**BASIS OF DESIGN EXCEPTION**

County: Cherokee Rd. / Route: S-41 (Beech St.) Const. Pin: 40205 BR01  
From: S-167 (13th St.) To: S-633 (Goldmine Springs Rd.)  
Length: 0.10 miles MPO / COG Appalachian COG  
Work Type: Replace bridge over Peoples Creek  
Functional Classification: Urban Collector

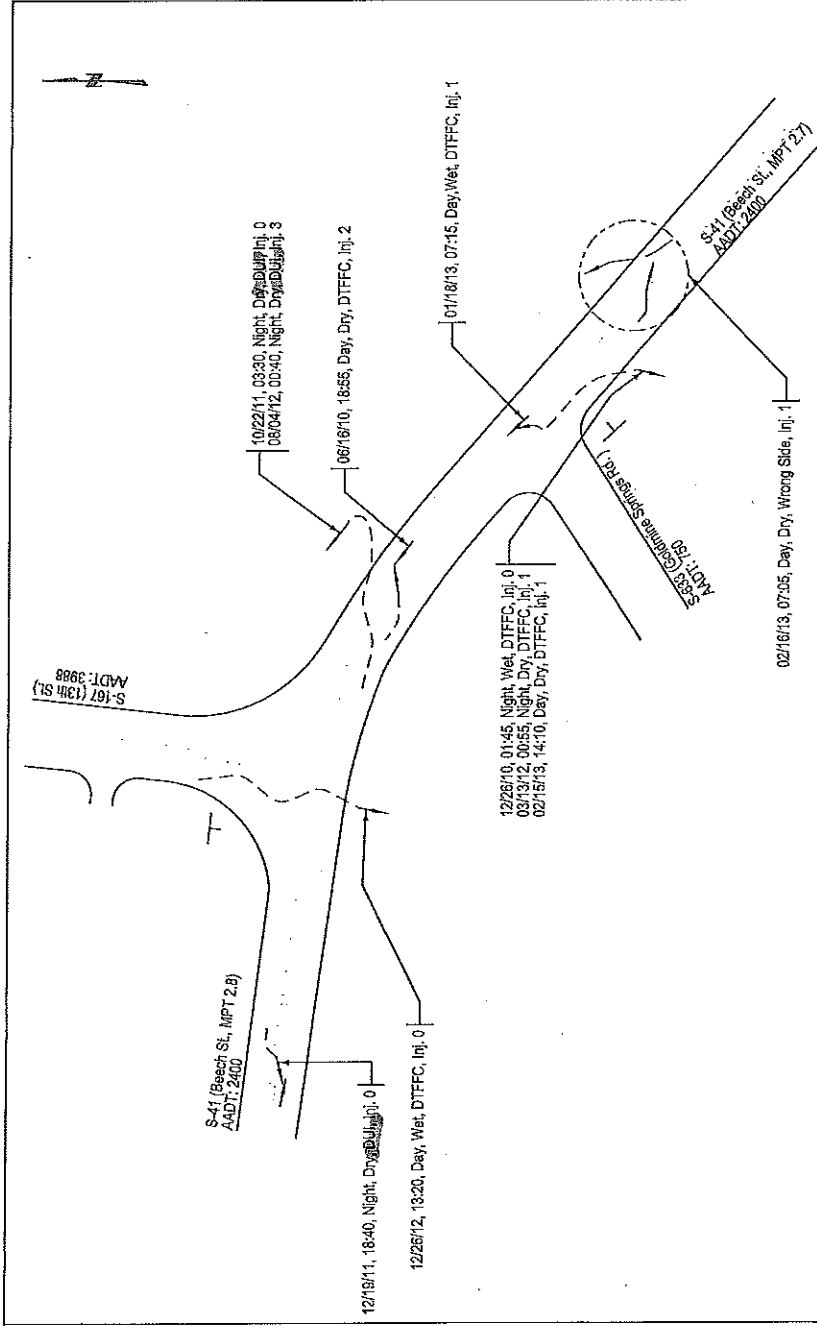
The shift in alignment of the structure away from the substation has several impacts that made this option not feasible. First, the shift resulted in negative impacts to the intersection of SC-41 and Goldmine Springs Road causing an awkward stop condition where the driver is forced to look back over their shoulder (to the left and down/across the bridge) to check for oncoming traffic. The only way to correct this is by realigning Goldmine Springs Road which could potentially result in the taking of a home. This shift also increases the skew angle between the new structure and the creek resulting in a longer bridge. Any option that involves a change in the existing alignment of the structure has the potential to adversely impact many utilities – both overhead and underground. See chart below for a breakdown of estimated costs associated with each option.

**Option 1** - increase radius by shifting roadway towards substation at intersection of 13<sup>th</sup> St. and S-41.

**Option 2** - increase radius by shifting roadway towards transmission tower and extended curve across bridge.

SUBJECT TITLE: Collision Diagram

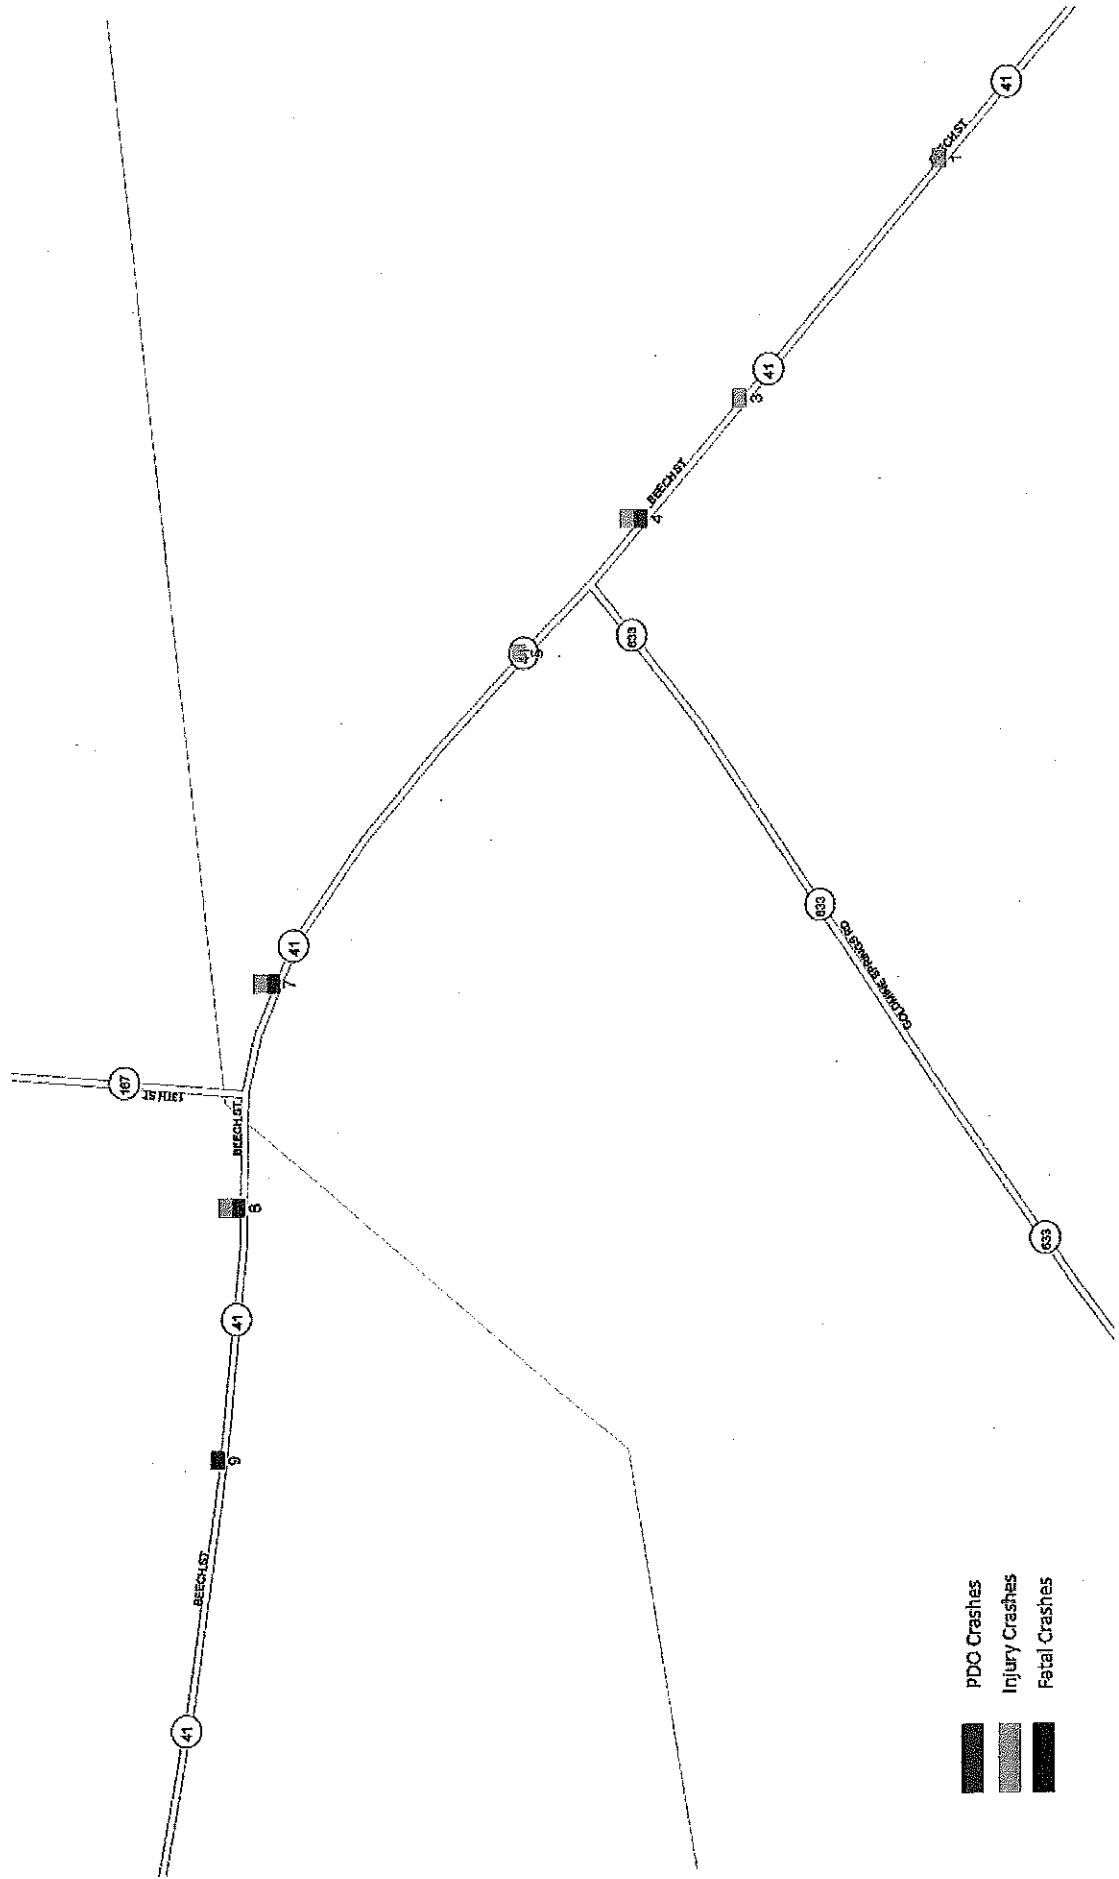
(Attach additional Sheets as needed) As seen in the attached crash summary, very few crashes have occurred within the project limits (10) over the last 3 yrs. Even fewer have occurred on the curve with the substandard design speed (2 crashes - see Stack #7). While a simple comparison using the number of crashes for this short section of roadway may be elevated, 5 of the crashes occurred at night and 3 were the result of DUI. Also, further analysis from the Traffic Engineering Office has revealed that this intersection is improperly signed as a curve with 25 mph regulatory advisories. (see attached)
